Explanation of Significant Differences to the Final Record of Decision for Parcel C

**Hunters Point Shipyard
San Francisco, California**

October 2014

**RESPONSE TO COMMENTS ON
DRAFT EXPLANATION OF SIGNIFICANT DIFFERENCES TO THE
FINAL RECORD OF DECISION FOR PARCEL C, HUNTERS POINT NAVAL
SHIPYARD, SAN FRANCISCO, CALIFORNIA**

Parcel C Location

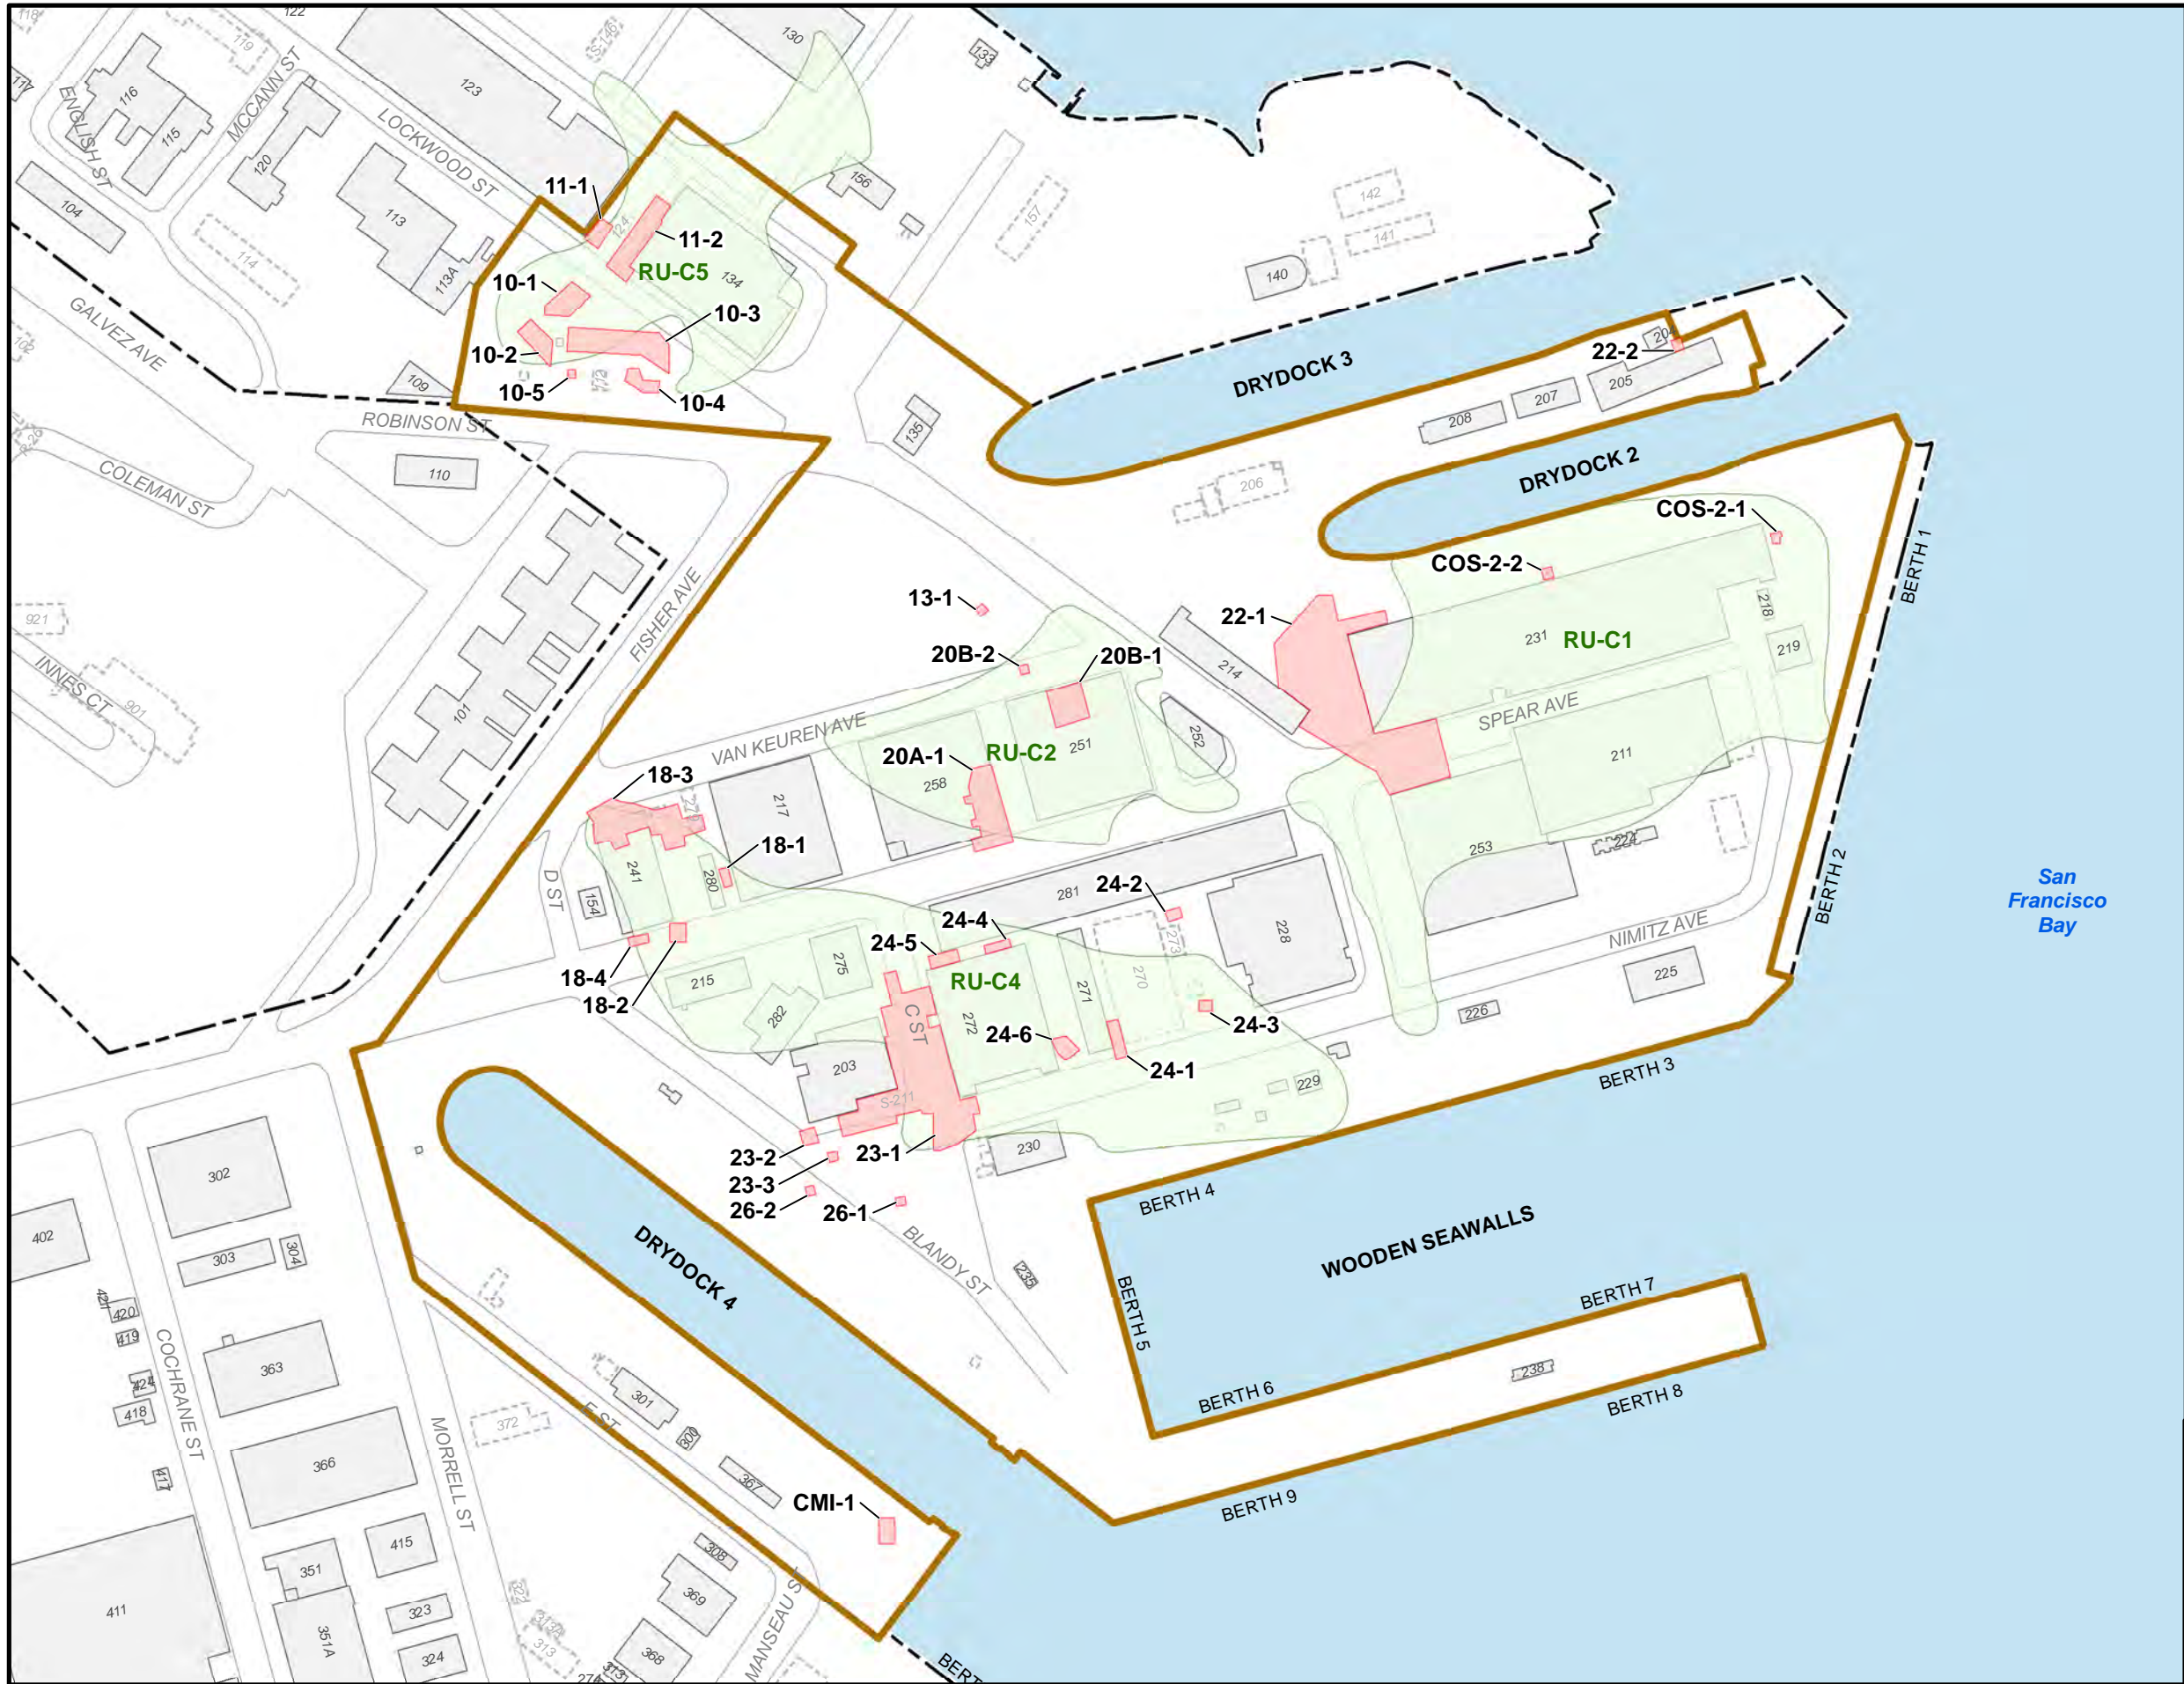
4.	Section 2.2.1, Site Risks for Soil, page 2-2, 2nd full paragraph	Redevelopment blocks are referred to in the text but are not shown on a figure. Consider including a figure showing land use and redevelopment blocks used in baseline HHRA.	The redevelopment blocks were added to Figure 2-2. Please also see the response to DTSC Comment 1.

13.	Table 4-1, Action Levels	Please list source of TPH RG.	The total petroleum hydrocarbons (TPH) RG was determined in the ROD.
Minor Comments			
1.	Figure 2-2, Parcel C Location	Should blue dashed line for “Groundwater Plume Area” be removed from Legend?	Thank you for your comment. We believe that showing the groundwater areas is beneficial to the overall figure.

Revised Excavation Areas
Explanation of Significant Differences to the
Final Record of Decision for Parcel C
Hunters Point Naval Shipyard San Francisco, California

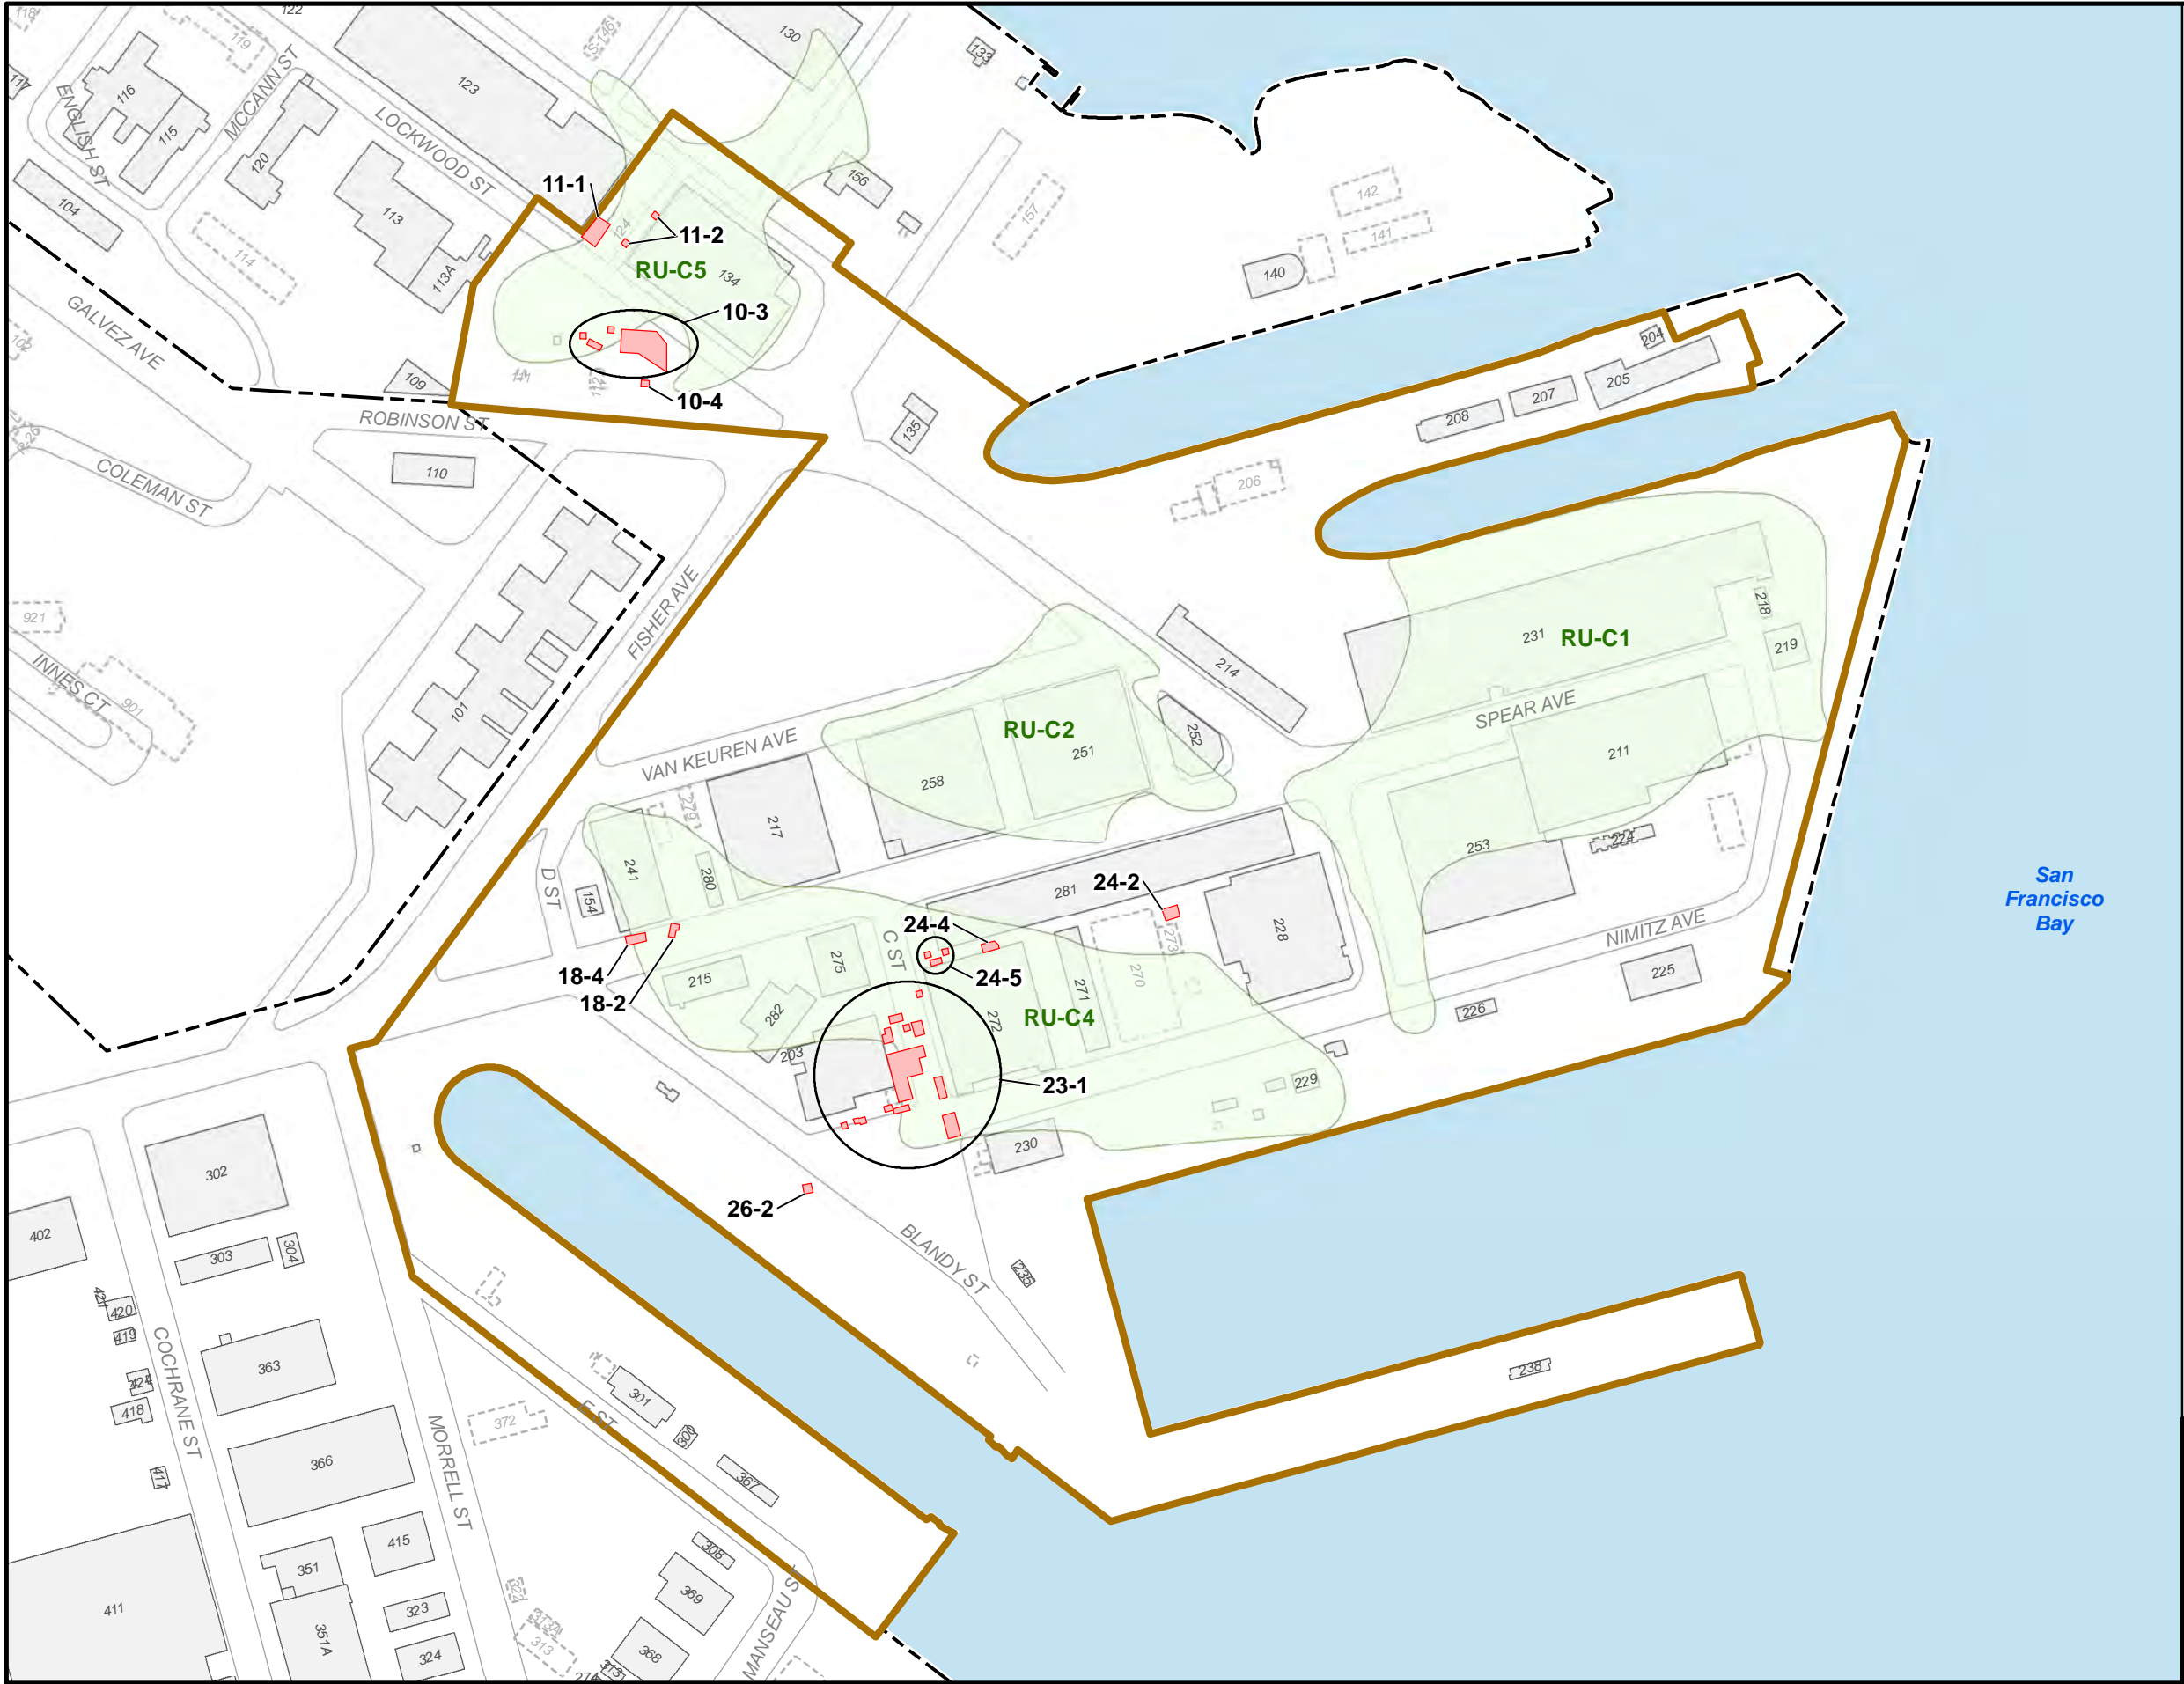
(b) Soil Excavation 24-3 subsection. The figure presenting the Revised Excavation Areas (Figure 4-2) should be revised to accurately reflect that excavation in this area will no longer take place. Please consider removal of excavation area 24-3 from the figure.	(b) Figure 4-2 will be edited to remove Excavation Area 24-3. Additionally, an introductory sentence will be added to Section 4.2.2 clarifying that Excavation Area 24-3 will not be included in the Remedial Action.

11.	Figure 4-2, Revised Excavation Areas	Please show excavations no longer proposed for removal in a different color from revised excavation boundaries.	Figure 4-2 was revised to remove excavation areas that are no longer proposed for removal (22-2 and 24-3) and to only show those excavation areas with revised boundaries.
